Product Change Notification / MFOL-04PKQY369

CCB 4630.002 Final Notice: Qualification of STA as an additional assembly site for USB3340-EZK, USB3340-EZK-TR, USB3370B-EZK and USB3370B-EZK-TR catalog part numbers (CPN) available in 32L VQFN (5x5x0.9mm) package.

CCB 4630.002
Pre and Post Change Summary
PCN# MFOL-04PKQY369

**QUALIFICATION REPORT SUMMARY
RELIABILITY LABORATORY**

Lead Frame Comparison

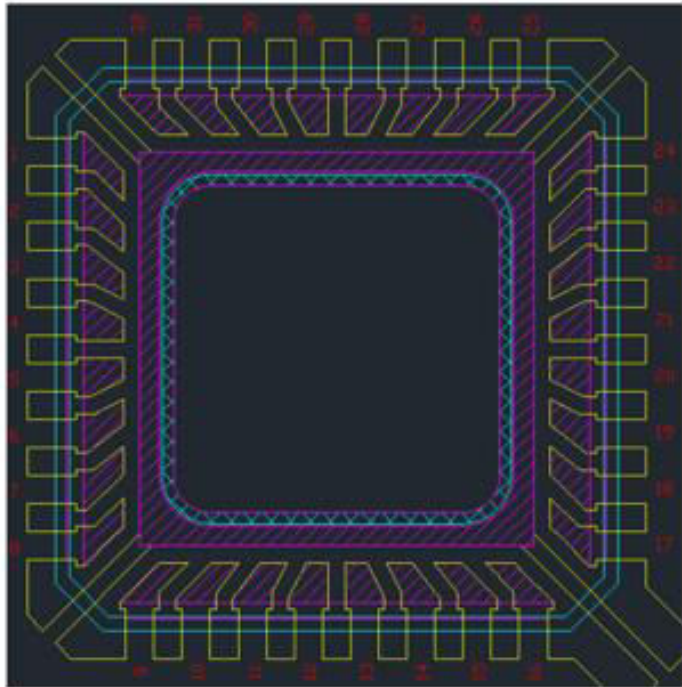
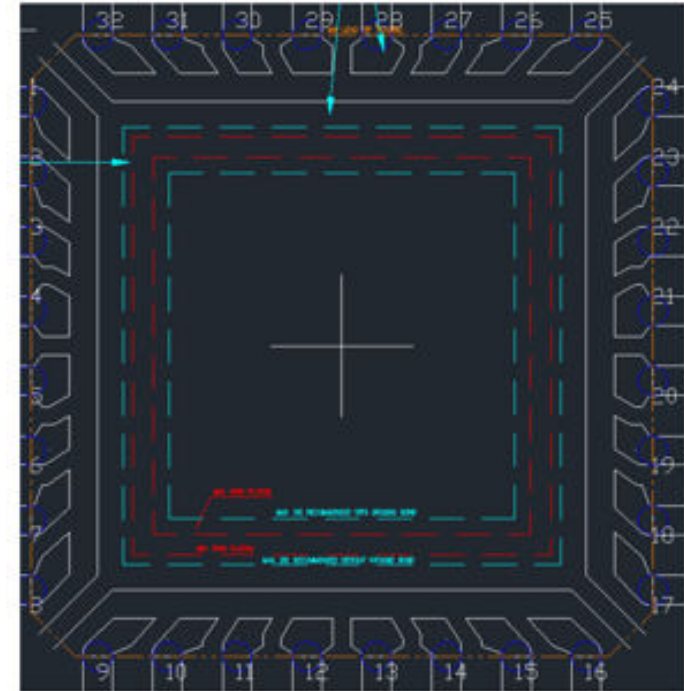
ASE

Lead frame
material

C194

STA

Lead frame
material

C194
